QAPP AMENDMENT FORM: Amendment #7

DATE FORM SUBMITTED: 7/23/07

QAPP Title Quality Assurance Project Plan for the Ambient Air Monitoring Program

130 Liberty Street Deconstruction Project

3-Dimensional View of Air Monitoring Stations from The South

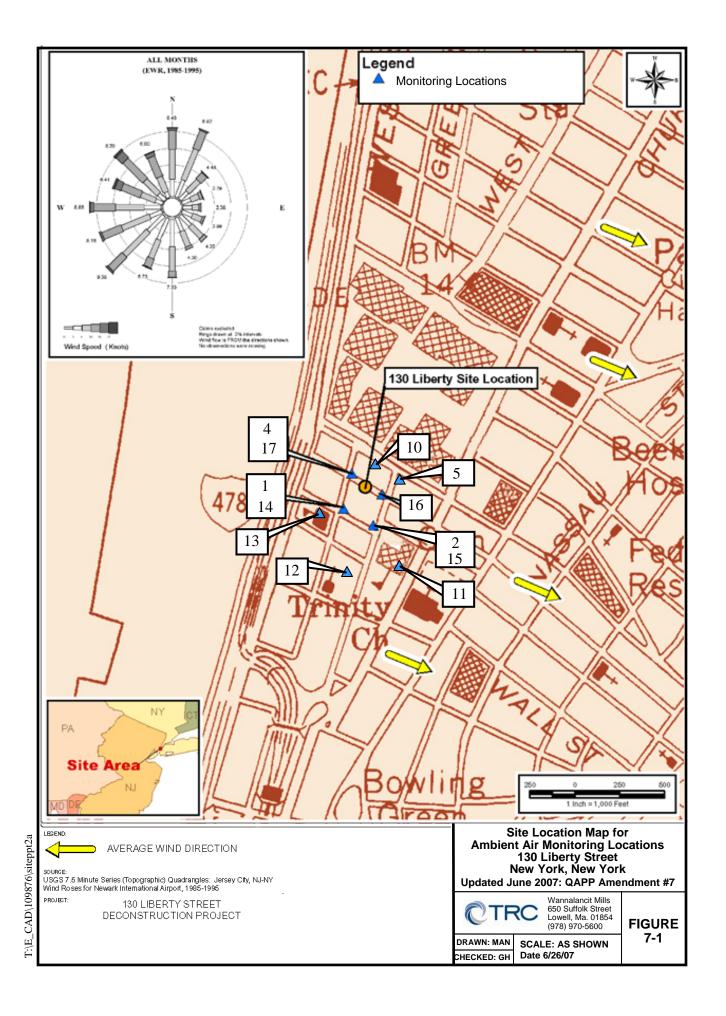
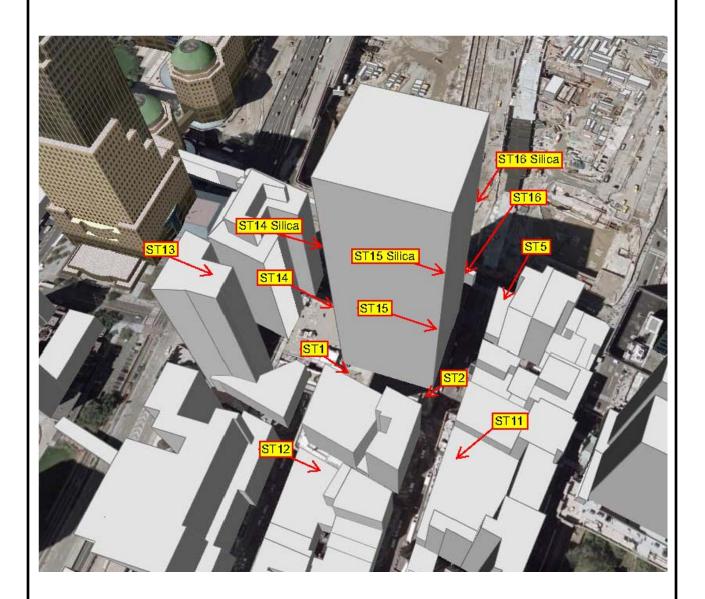
<u>Figure 7-1</u>: The locations of the current array of air monitoring stations are not accurately depicted on this figure. This figure has been updated to more accurately reflect the current locations of the monitoring stations. In addition, two new figures will be added to the QAPP (Figures 7-3 and 7-4) which will provide a three-dimensional view of all air monitoring stations.
